City Campus Student Accommodation Building B

Drawing Name
HARDWORKS - GROUND FLOOR

Issued under the *Environmental Planning and Assessment Act 1979*
Approved Section 4.55 (1A) Modification Application
Approved Application No: SSD 61618229 Mod 1
Approved on: 27 February 2026
Signed: AW Sheet No: 2 of 8

Project Status
SSDA MODIFICATION

Drawing No.
402
Drawing Name
SOFTWARES - LEVEL 1

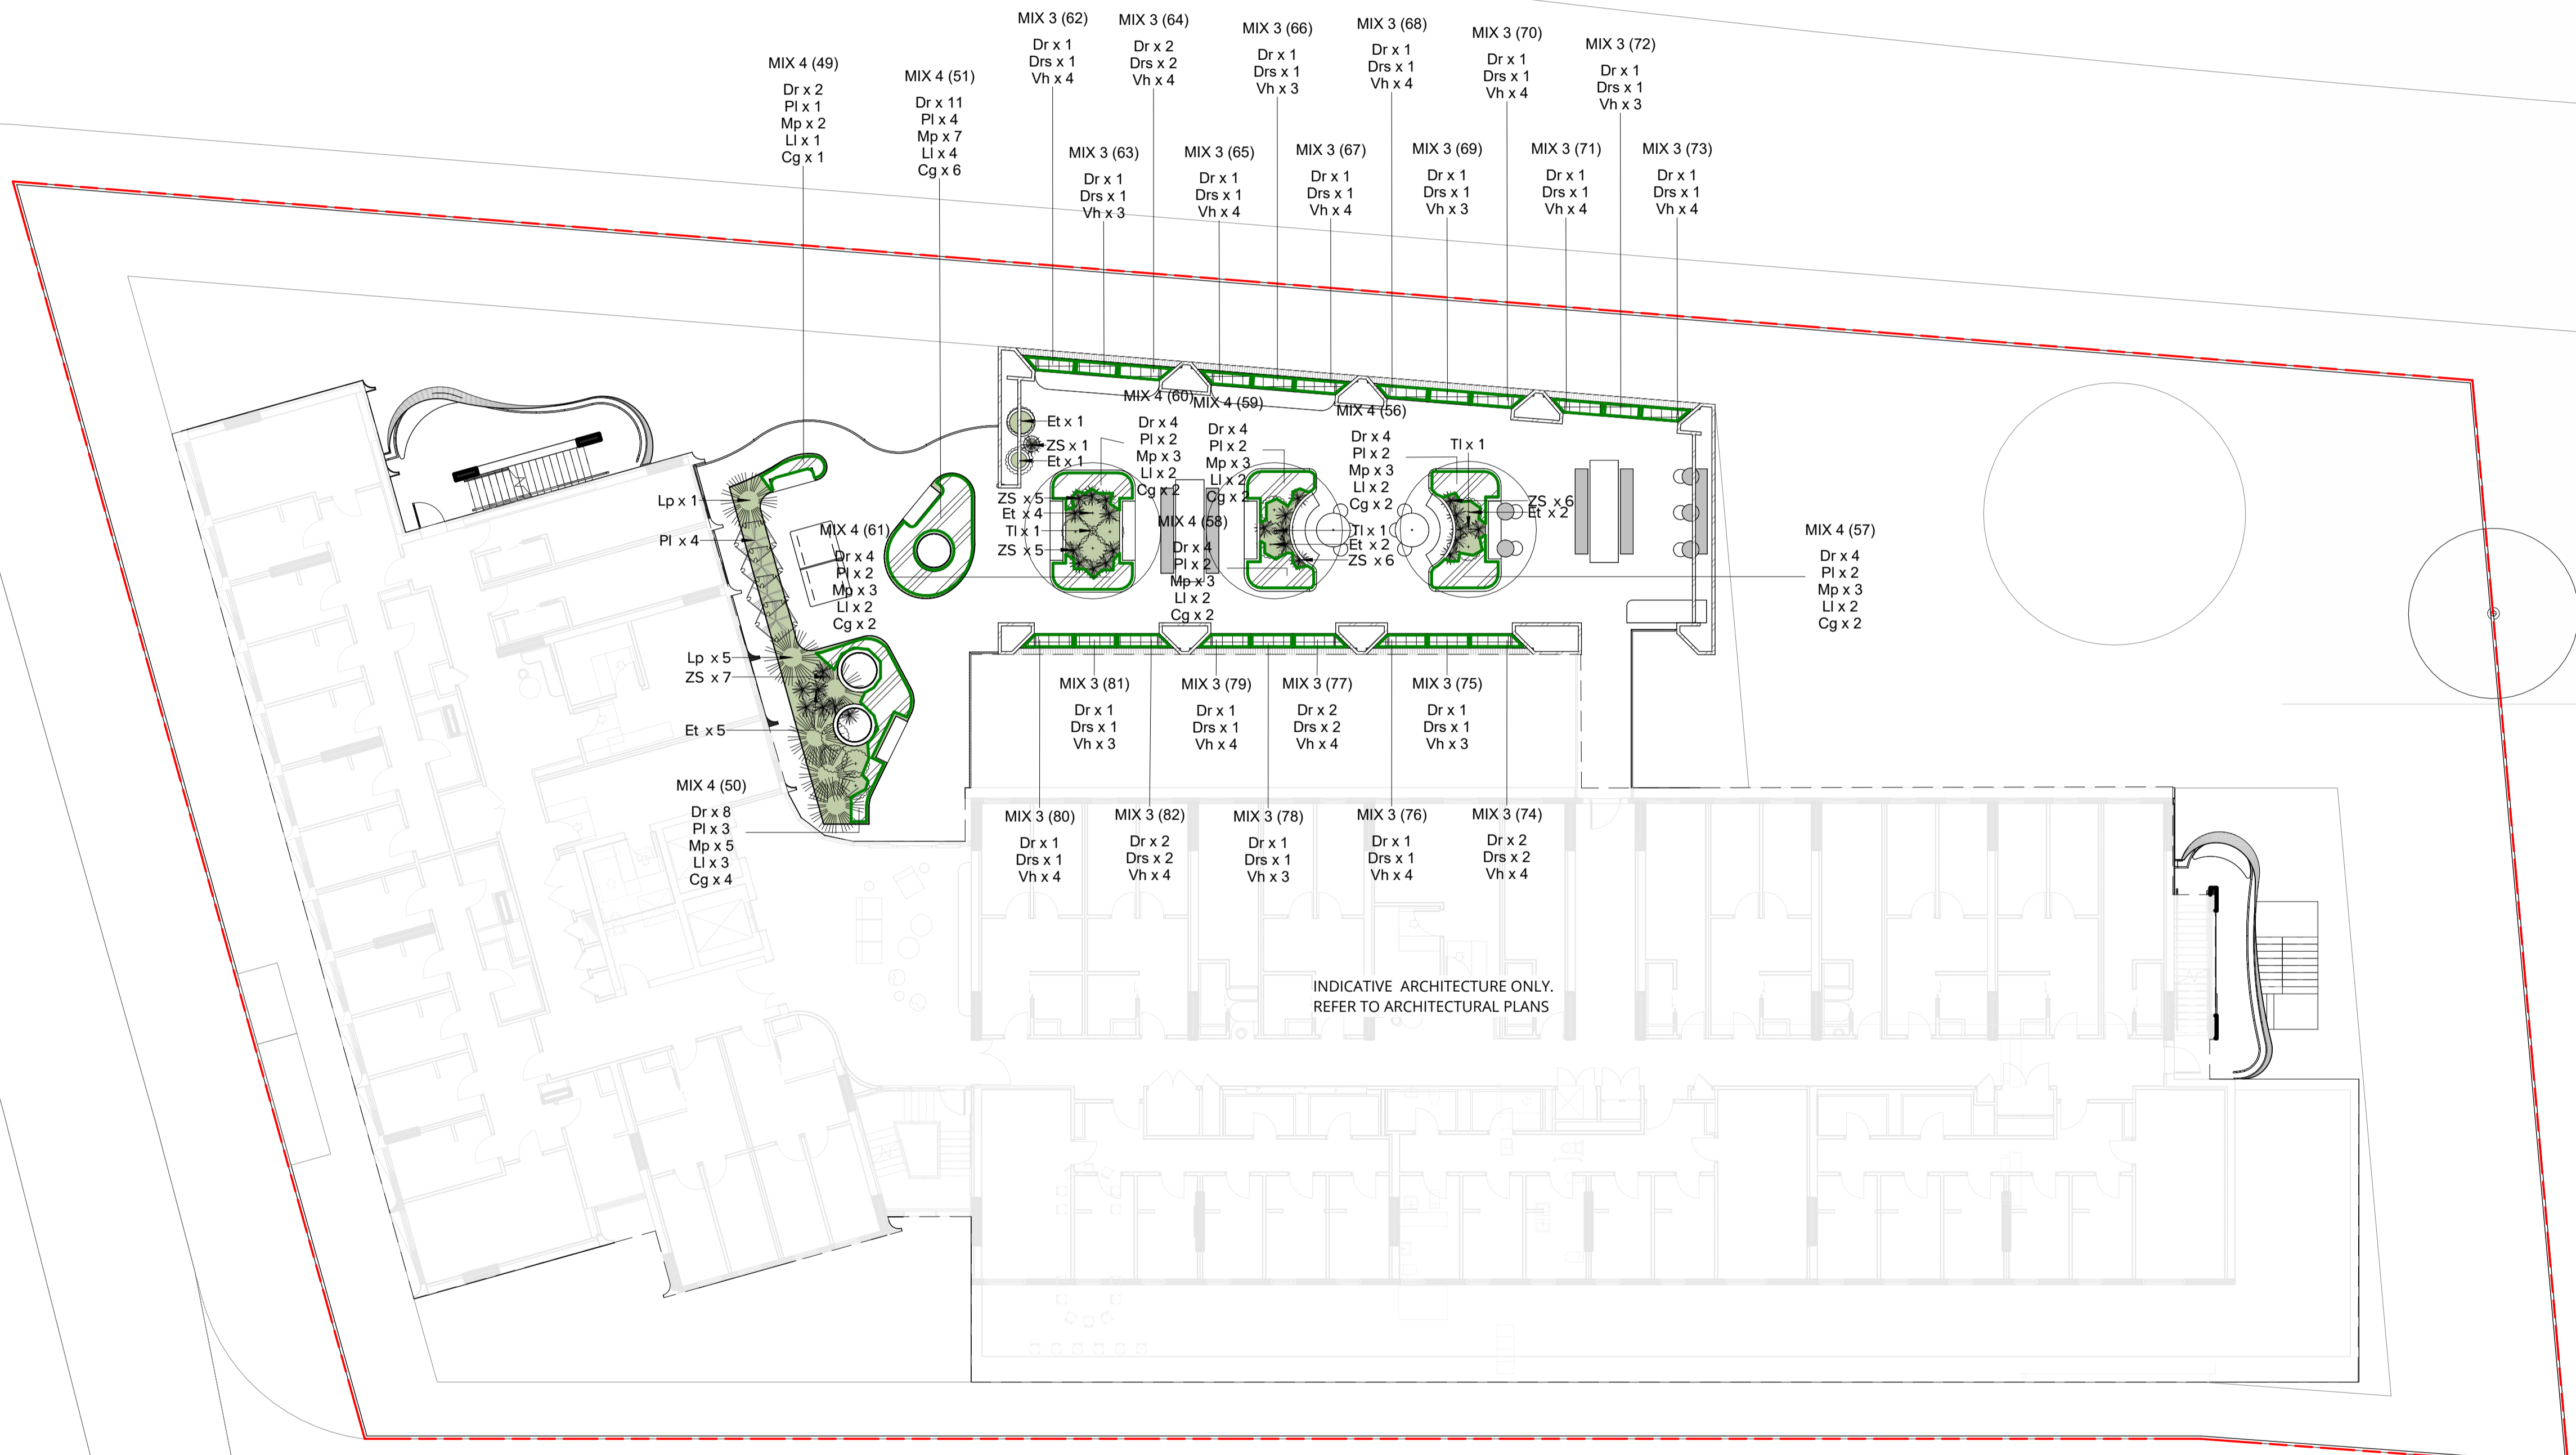
No.	Design Change
1	Removal of trees to Civic Lane garden bed.
2	Realignment of rail heritage interpretation.
3	Addition of stairs to Worth Place.
4	Realignment of garden bed to Wright Lane
5	Addition of handrail to raised boardwalk.
6	Additional of timber seating nooks.
7	Realignment of staircase, pushed slightly south
8	Egress to loading bay.
9	Column shape/form.
10	Revised arrangement of central courtyard.
11	Revised arrangement of level 1 terrace.
12	Addition of external bike racks.
